EVOLUTION OF THE SLIMLINE

SLIMLINE CLASSIC

SLIMLINE 1ST JANUARY 2017

SLIMLINE 2020

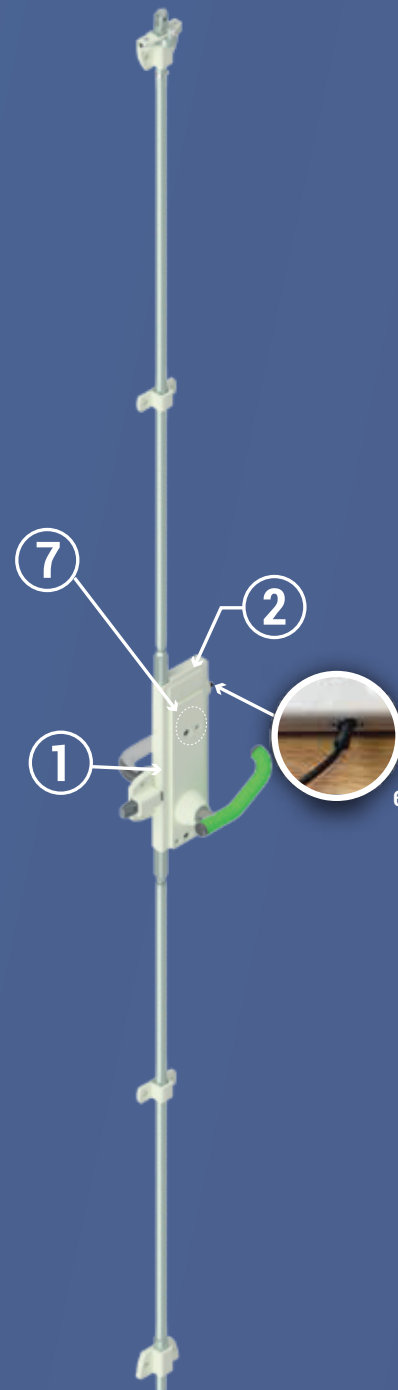
1. Product paint finish is Grey White (RAL 9002)
2. Centre lock module with solenoid bulge
3. Panic escape version available with green panic plate to meet BS EN 1125
4. Emergency escape version available with green push pad to meet BS EN 179
5. Emergency escape version available with green lever handle to meet BS EN 179
6. Access control solenoid/motorised/monitored locks have 5 m cables hard wired into the lock body
7. No facility for bolt through fixings for the new 'G' type cylinder guards

Fixing foot print – Drawing reference 14652:02:000

Lock body length 289 mm, lock body depth 94 mm, lock body thickness 22 mm

Cable outlet position – Drawing reference 14652.02.000

Lock and bolt status monitoring with access control model requires option M for bolt and status monitoring and option N for lock status monitoring

3/8" Spindle shaft

G' type cylinder guard, preparation hole increases from 57 mm to 63 mm diameter hole – Drawing reference 14652.03.000

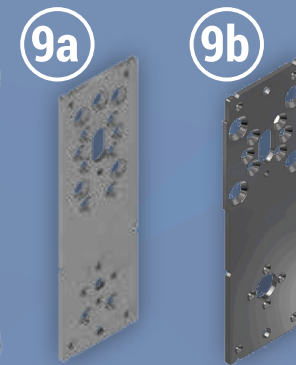
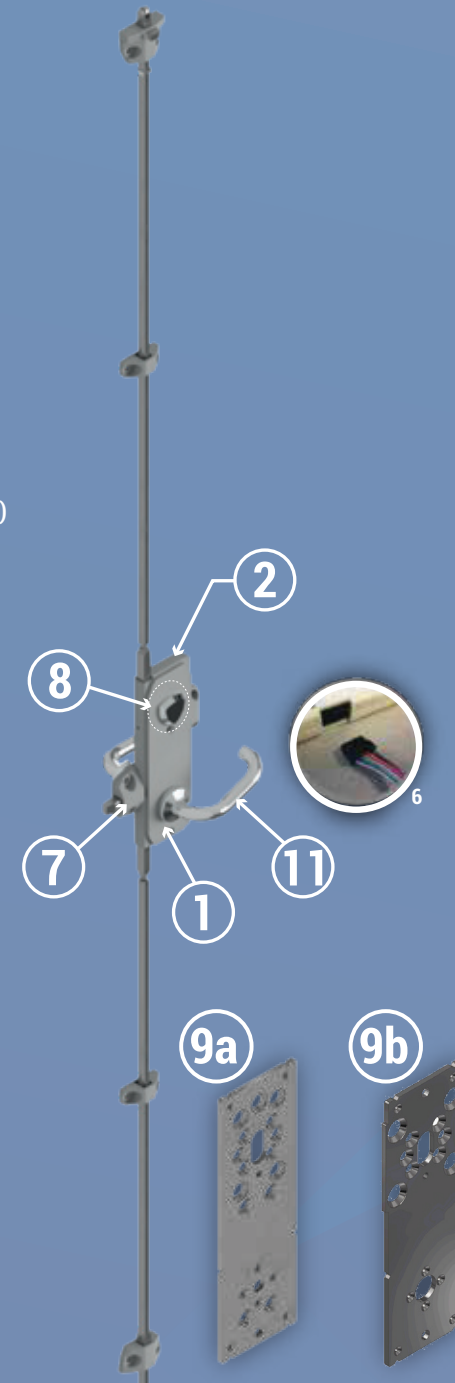
1. Product paint finish is Aluminium White (RAL 9006) (Effective as of 1st September 2017)
2. No solenoid bulge
3. Panic escape version available with SAA panic plate as standard or stainless steel round bar both meeting BS EN 1125

4. Emergency escape version available with aluminium push pad to meet BS EN 179
5. Emergency escape version available with stainless steel emergency escape lever handle to meet BS EN 179

6. Plug in electrical connector for access control solenoid/motorised and/or monitoring facility (cable length 5 m)
7. Stainless steel cast bolt guides for improved strength suitable for use with M8 stainless steel fixings

8. Three methods of securing the cylinder guard – standard, surface bolt through fixing and mortice bolt through fixing only possible up to GSS4 cylinder guard

9. 5mm load plate available for cost effective and speedy preparation. Standard W15 load plate (9a). Load plate to suit ultimate cylinder guard available as option W16 (9b)

10. Bolt enhancement packs for greater security and blast resistance – 15 mm and 25 mm bolts available
11. New fixing positions for new 4 fixings stainless steel lever handle – Drawing reference 14652.00.000

Fixing foot print – Drawing reference 14652.02.000

Lock body length 289 mm, lock body depth 94 mm, lock body thickness 21 mm

Can be mortice fitted with slimmer 22 mm body or 26 mm when installed within a steel mortice cassette

Cable outlet position have moved – Drawing reference 14652.02.000

Lock & Bolt status monitoring is standard with access control version (no additional code required for monitoring)

Lock & bolt status monitoring for mechanical lock versions requires Option M

Improved spring design reducing release force, yet stronger and smoother

8mm spindle/shaft (Effective as of 1st September 2017)

'G' type cylinder guard, preparation hole increases from 57 mm to 63 mm diameter hole – Drawing reference 14652.03.000

In house cycle testing to over 4 million cycles
